May 23, 2013

**ADDENDUM NO. 1
TO THE
INVITATION TO BID(ITB) - 4293
FOREST AVENUE IMPROVEMENT PROJECT
FOR THE
CITY OF ANN ARBOR, MICHIGAN**

The following changes, additions, and/or deletions shall be made to the Bid Documents for the Forest Avenue Improvement Project, for the City of Ann Arbor, Michigan, Invitation To Bid No. ITB - 4293.

PROJECT MANAGEMENT - PUBLIC SERVICES - CITY OF ANN ARBOR
FOREST AVENUE IMPROVEMENT PROJECT
TRANSFORMER PARK
CONSTRUCTION PLAN

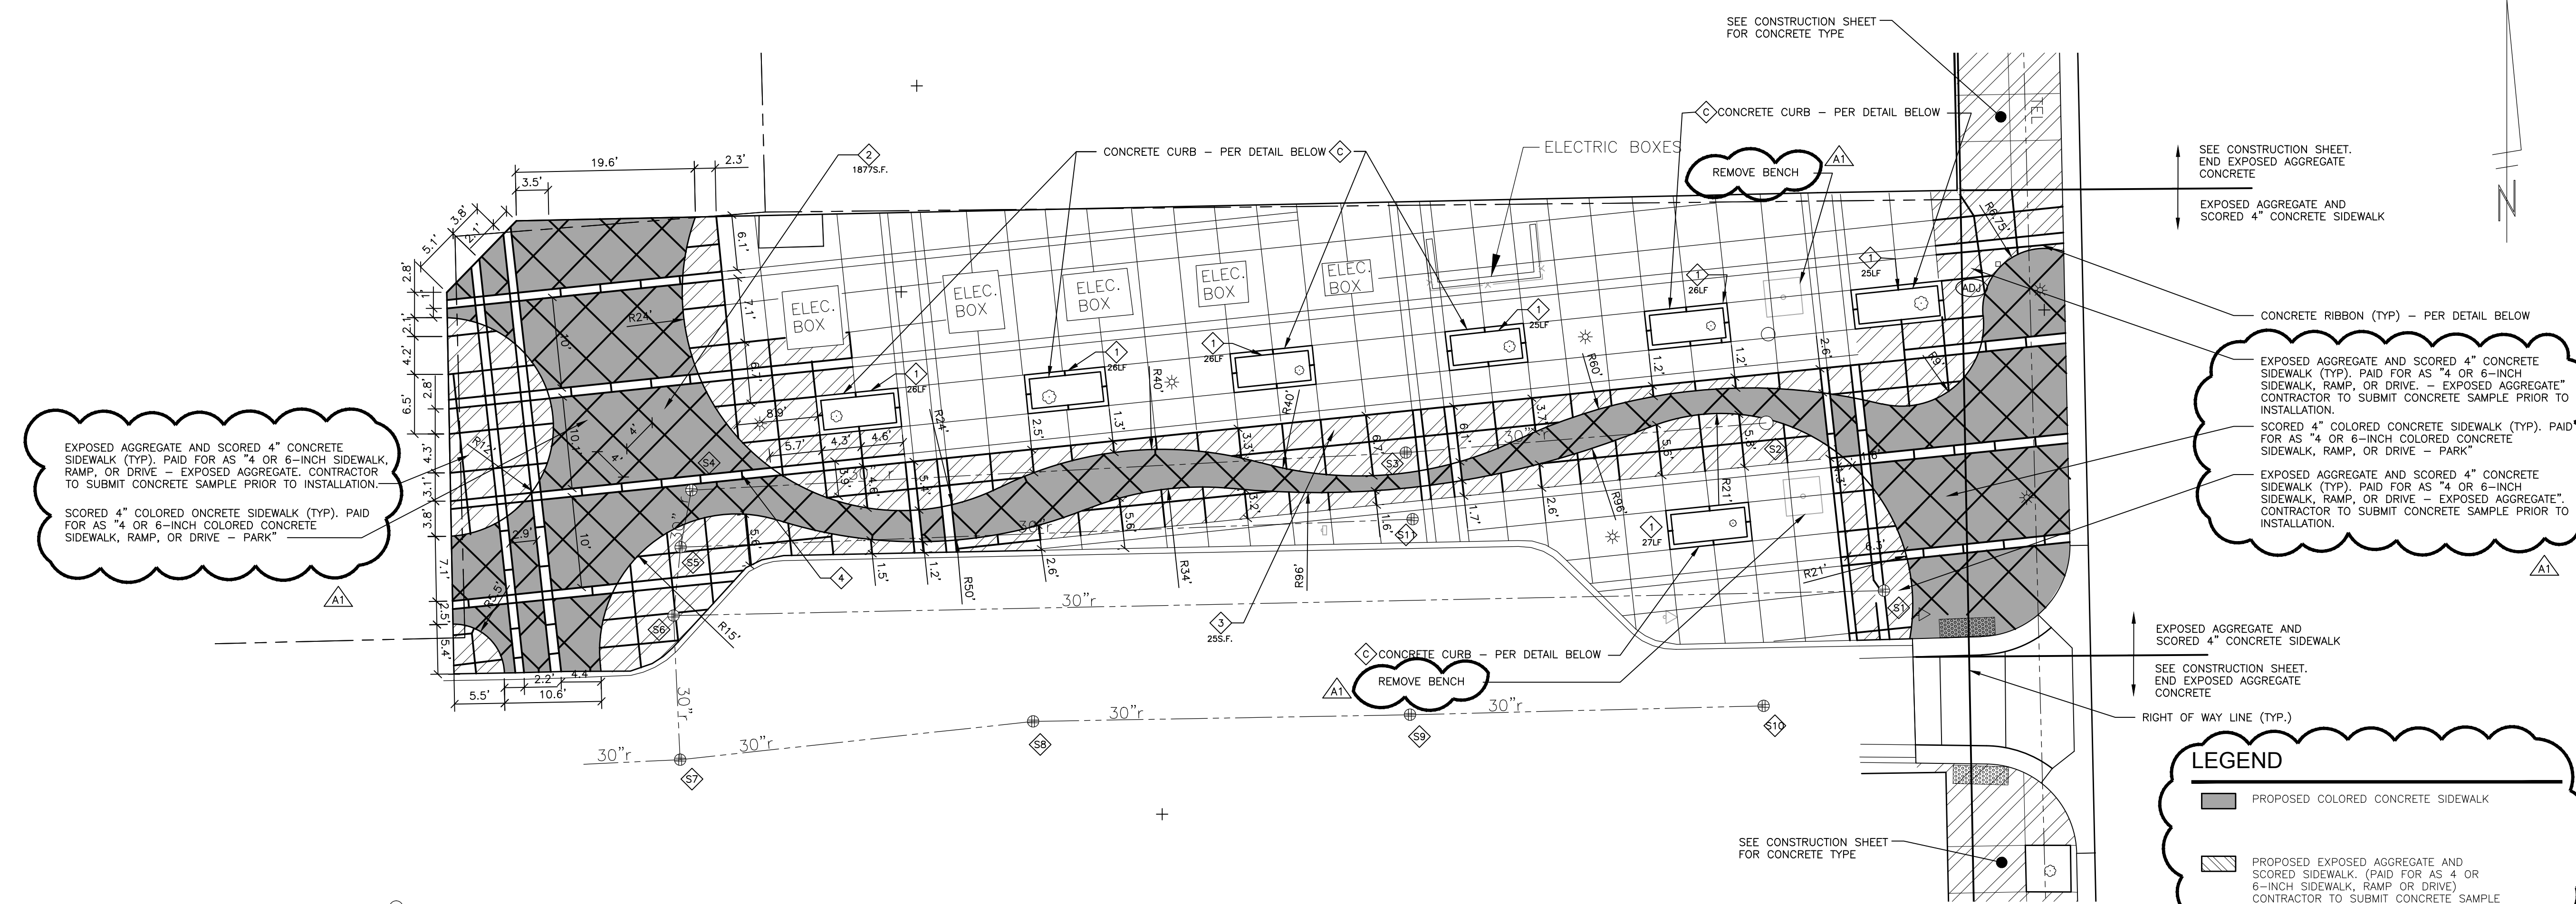
- Item #1: Contract Documents, BF-1 through BF-3;
Replace pages BF-1 through BF-3 with the attached revised BF-1(ADD-1-2) through BF-3(ADD-1-4).
- Item #2: Contract Documents, Detailed Specification:
Replace pages DS -4, DS - 8, DS - 18, DS - 19, DS - 40, DS - 43, DS - 53, DS - 54, DS - 55, DS - 57, DS - 58, and DS - 59 with the attached revised pages ADD - 1-5 through ADD -1-16
- Item #3: Contract Plan Set; replace plan sheets 10, 11, 12, 15 and 16 with attached plan sheets.
The revised plans show changes to the Traffic Control and Transformer Park reconstruction.

EXPOSED AGGREGATE AND SCORED 4" CONCRETE SIDEWALK (TYP.) PAID FOR AS "4 OR 6-INCH SIDEWALK, RAMP, OR DRIVE - EXPOSED AGGREGATE". CONTRACTOR TO SUBMIT CONCRETE SAMPLE PRIOR TO INSTALLATION.

SCORED 4" COLORED CONCRETE SIDEWALK (TYP.) PAID FOR AS "4 OR 6-INCH COLORED CONCRETE SIDEWALK, RAMP, OR DRIVE - PARK"

PROJECT MANAGEMENT - PUBLIC SERVICES - CITY OF ANN ARBOR
FOREST AVENUE IMPROVEMENT PROJECT
TRANSFORMER PARK
GRADING & DRAINAGE PLAN

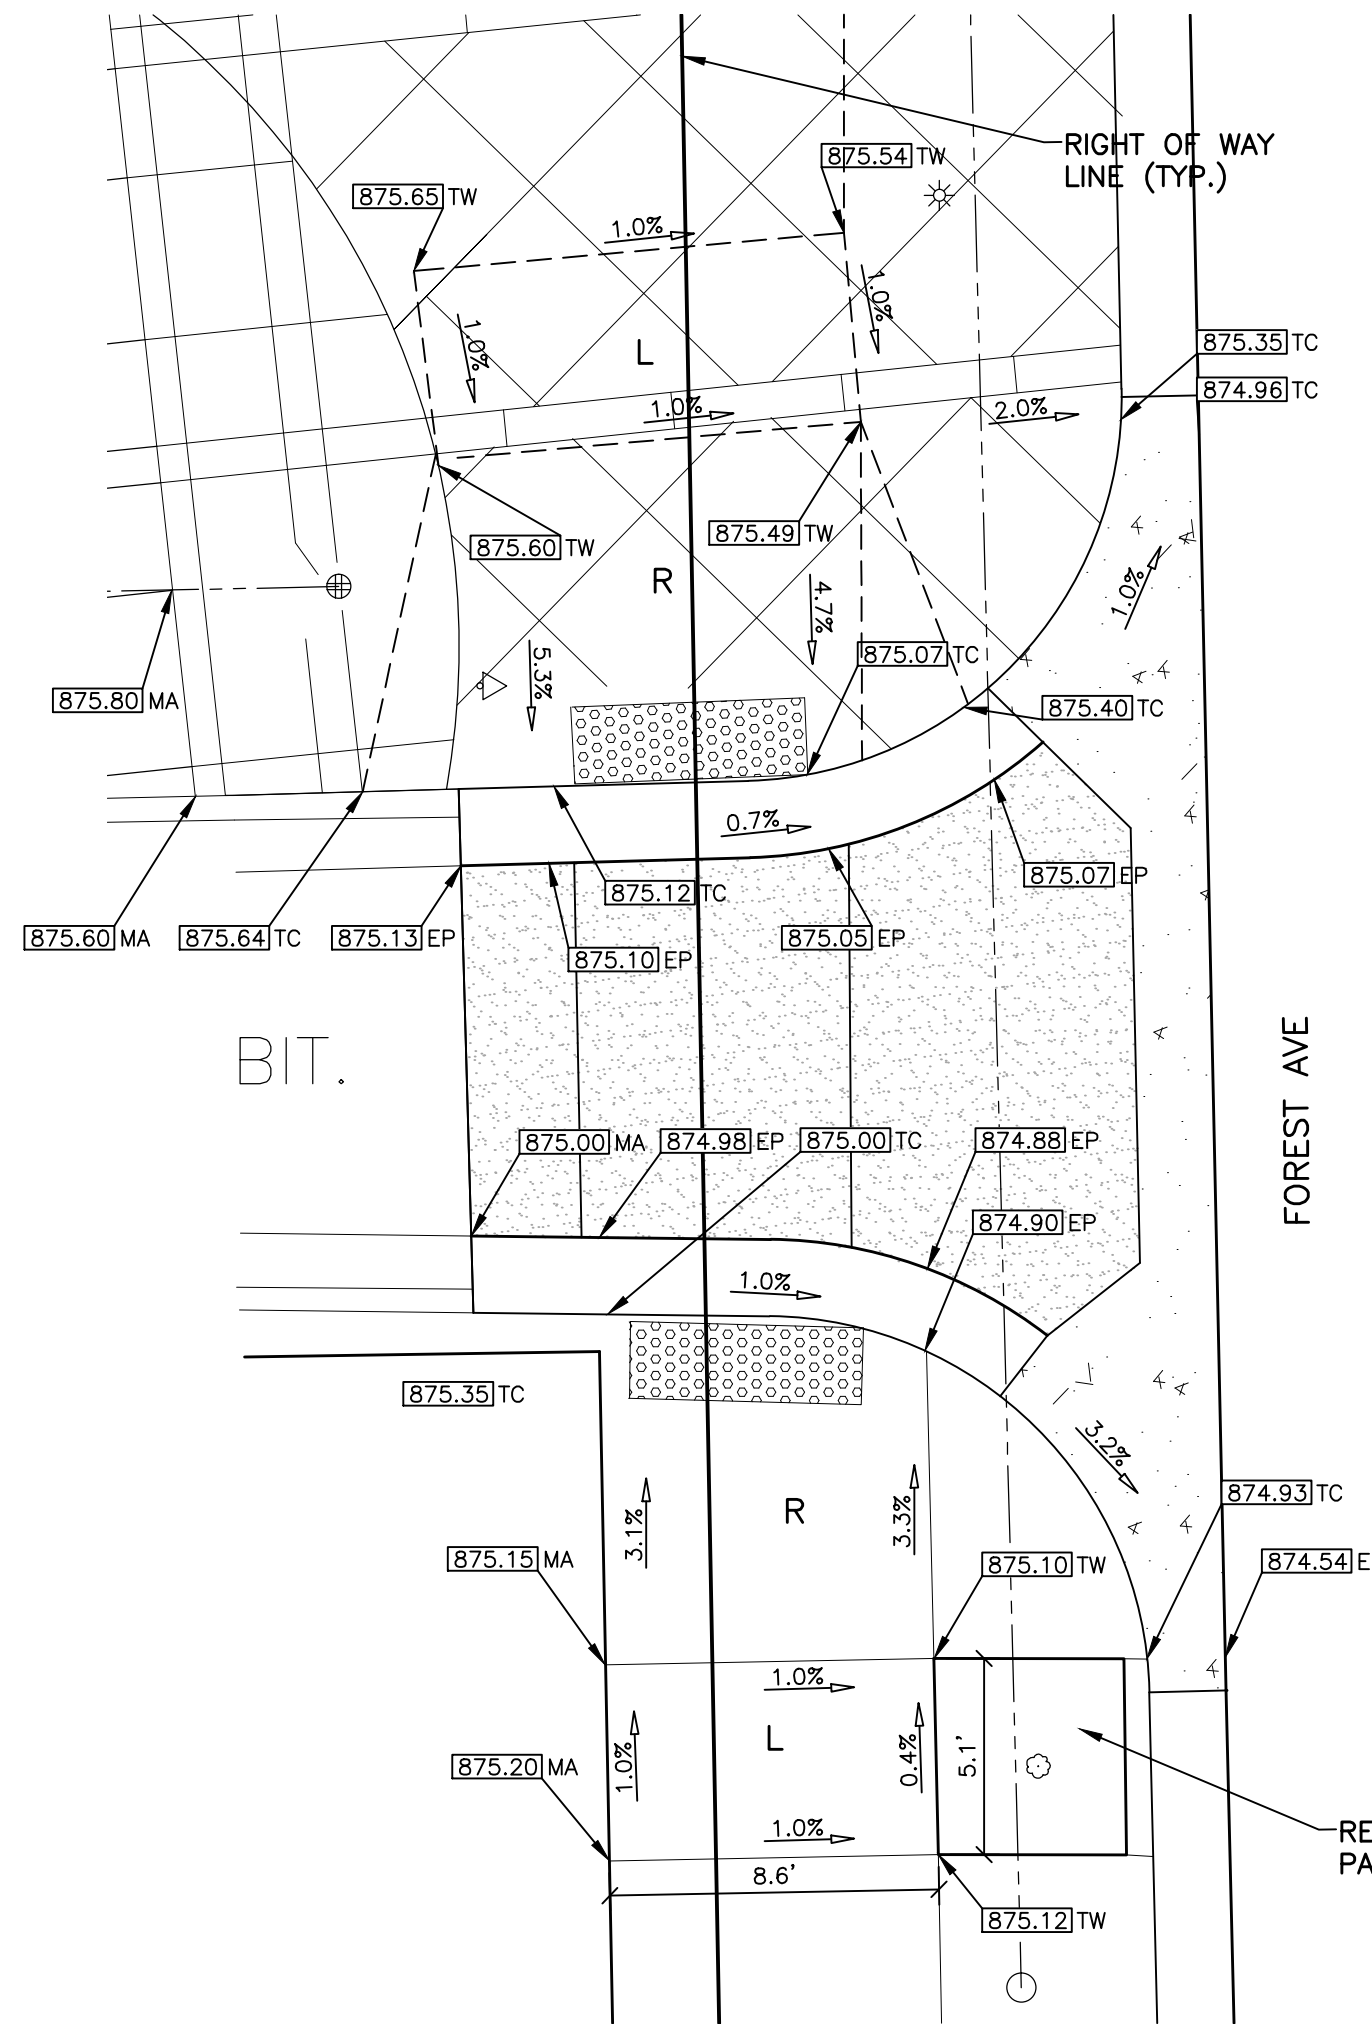
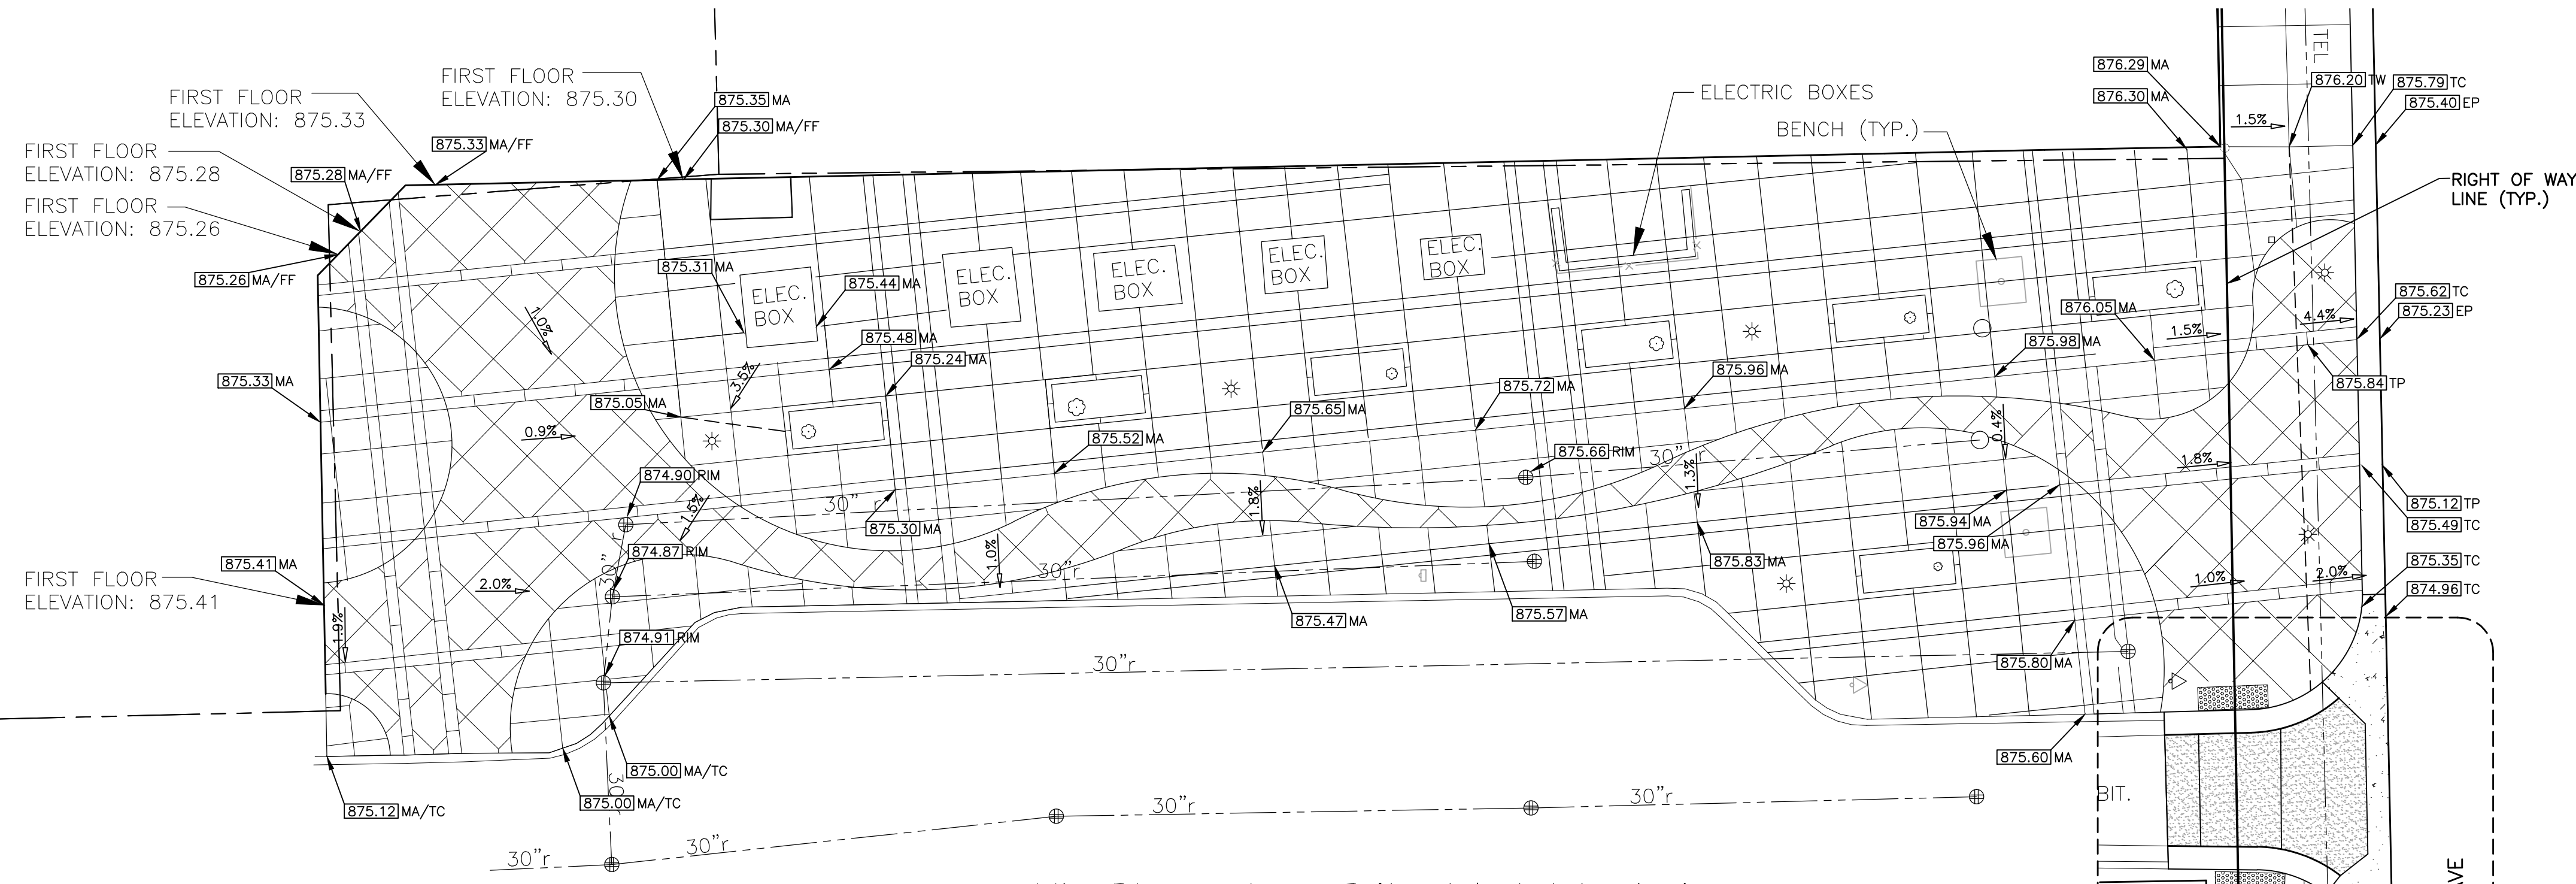
REV.	DATE	DESCRIPTION
01	05-08-2013	BID SET
02	05-22-2013	ADDENDUM #1
